Palo Verde Nuclear
Generating Station

**Subject: Palo Verde Nuclear Generating Station (PVNGS)
Units 1, 2, and 3
Docket Nos. STN 50-528/529/530
Proposed Amendment for Administrative Changes to
Technical Specification Figure 3.5.5-1, "Minimum Required
RWT Volume"**

**Proposed Amendment to PVNGS Unit 1, 2 and 3
Technical Specification Figure 3.5.5-1**

FIGURE 3.5.5-1
Minimum Required RWT Volume

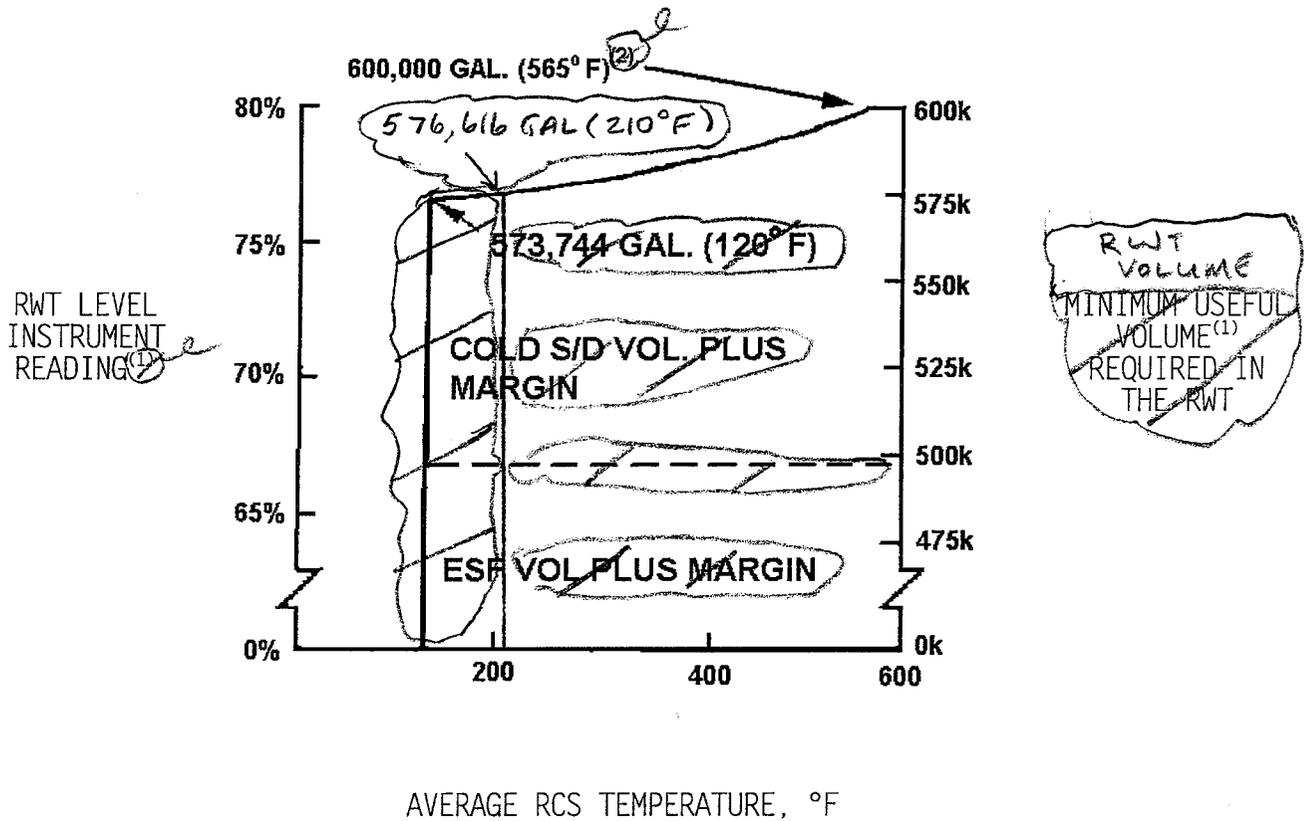
The proposed administrative TS amendment would revise TS Figure 3.5.5-1, "Minimum Required RWT Volume," to (1) relocate design bases information (but not the TS limits) to the TS Bases, (2) truncate the lower end of the RWT limit curve at 210°F, (3) re-title the right ordinate from "minimum useful volume in the RWT" to "RWT volume," and (4) delete the footnotes. The design bases information to be relocated are the portions of RWT volume that are shown for engineered safety features (ESF) volume (plus margin) and for cold shutdown volume (plus margin). These proposed changes are shown on a marked-up copy and a re-typed copy of Figure 3.5.5-1 in Sections G and H of this Enclosure.

The proposed change to truncate the RWT limit curve in Figure 3.5.5-1 to the lowest average RCS temperature of 210°F would be a human-factors enhancement. Since this figure is applicable only in modes 1, 2, 3, and 4, the lowest RCS temperature at which it is applicable is 210°F. This truncation would eliminate any potential confusion caused by this figure showing limits for operating conditions outside the modes in which this figure is applicable.

The proposed editorial change to re-title the right ordinate of the graph in Figure 3.5.5-1 from “minimum useful volume in the RWT” to “RWT volume” would make the graph consistent with the figure title and the RWT design bases.

The proposed editorial change to delete the footnotes from Figure 3.5.5-1 would eliminate unnecessary or redundant information from the figure. Footnote 1 is not necessary because it provides no useful information to the plant operators who ensure compliance within the RWT limits of Figure 3.5.5-1. Footnote 2 is redundant to the information provided in the figure, and provides no additional useful information to the plant operators.

(1) The tank level and volume shown are the useful level and volume above that in the tank which is required for vortex considerations.

(2) When average RCS temperature is > 565°F, the minimum useful volume required in the RWT is 600,000 gallons.

FIGURE 3.5.5-1
Minimum Required RWT Volume

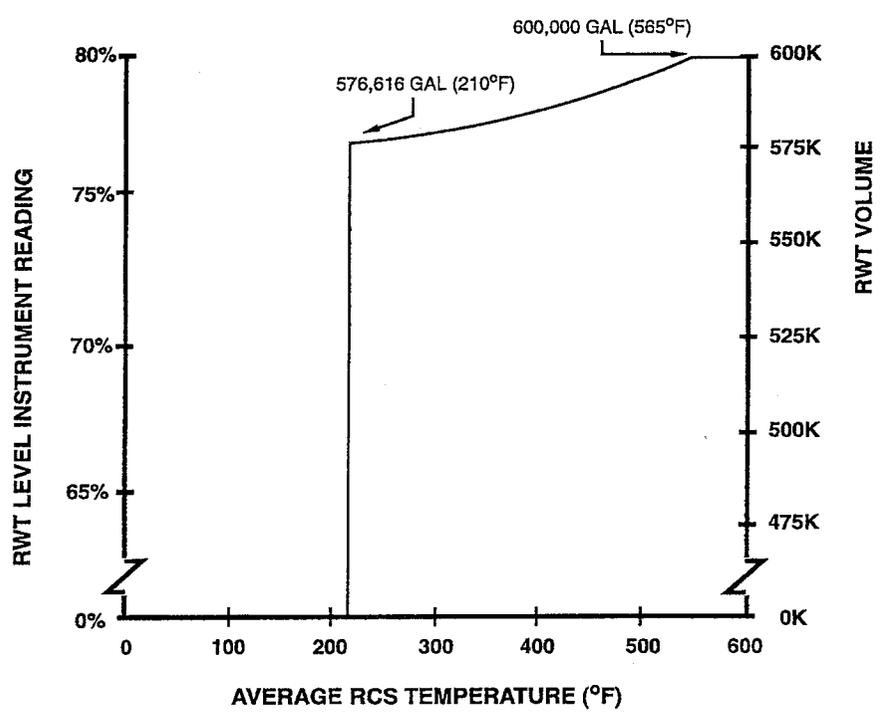
H. Retyped Technical Specification Page 3.5.5-3
